RENESAS TECHNICAL UPDATE

Product Category	Development Environment		Document No.	TN-EML-A139A/E	Rev.	1.00
Title	H8/36109 group expansion I/O board for the E6000: Problems with the timing of the slave interface		Information Category	Technical Notification		
Applicable Product	H8/36109 group expansion I/O board (model name: HS36109EIO61H)	Lot No.	Reference Document	H8/36109 group expansion I/O board HS36109EIO61H user's manual (REJ10J1320-0100)		
		0001 to 0031, 0BA0001B

Figure 1 H8/36109's Block Diagram

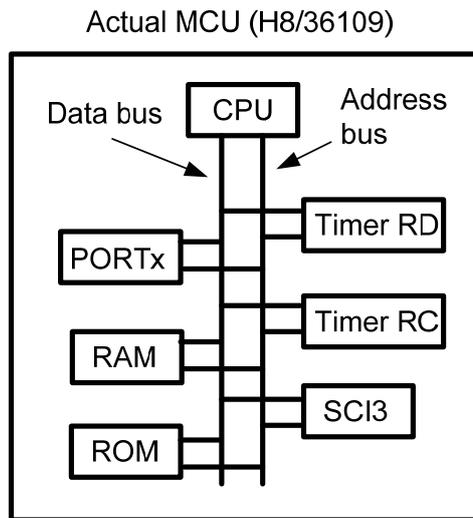
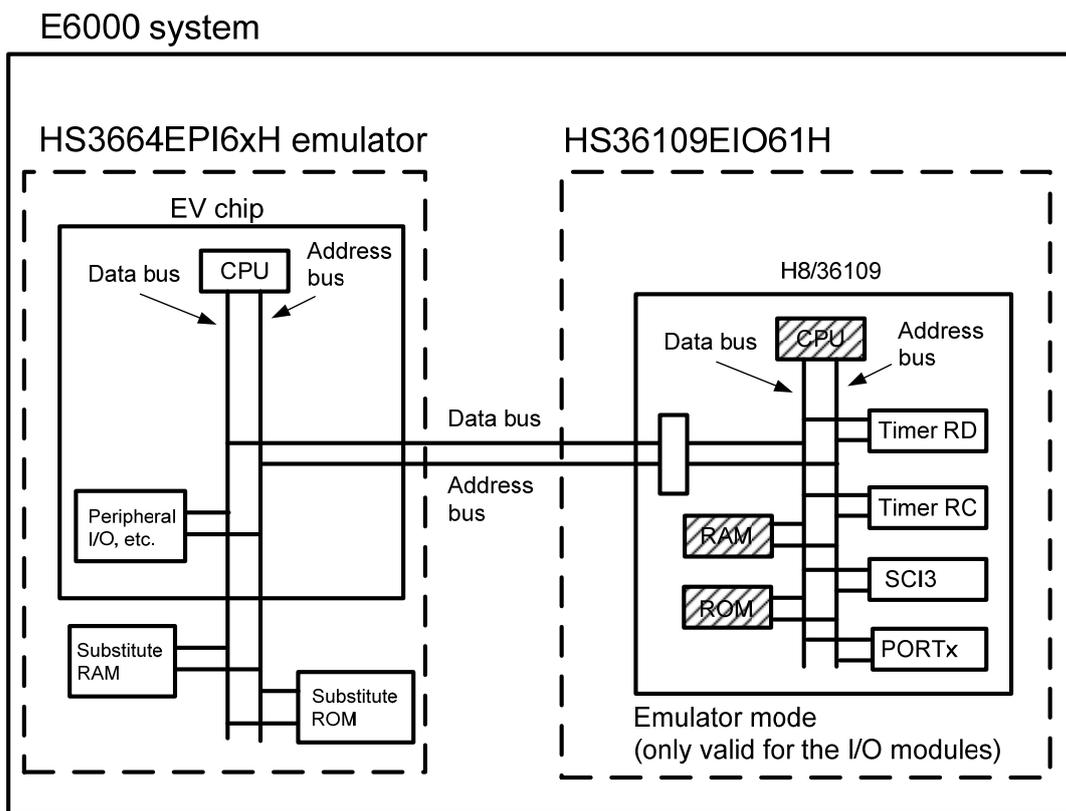
The actual H8/36109 is a single-chip MCU. Thus the address-bus, data-bus, and strobe signals are connected within the MCU (see figure 1).

1. This problem occurs only when the H8/36109 is used in emulator mode. The address-bus timing within the slave chip was earlier than the timing of other signals (data-bus and select signals) and this led to insufficient holding time between the slave address and select signals.

When the H8/36109 is used alone, however, this problem does not occur because of the difference in configuration as shown in the figures.

2. This problem occurs only when the H8/36109 is used in emulator mode. The timing of negating the slave-chip read signal (which is input from the EV chip to the slave chip) was earlier than the internal clock timing. So the data-bus signal output from the slave chip was negated a half clock cycle earlier and the EV chip could not read the correct value.

When the H8/36109 is used alone, however, this problem does not occur because of the difference in configuration as shown in the figures.

1. We will delay the timing of an input to the pins of the slave chip by approximately a half cycle (e.g. 25 ns in operation at 20 MHz), considering the delay time within the slave chip.

2. We will adjust the timing, considering the delay time within the slave chip, so that the ASESLRDN signal input to the slave chip will be negated following the falling edge of the T4 cycle with a delay in accord with the AC characteristics of the slave chip.
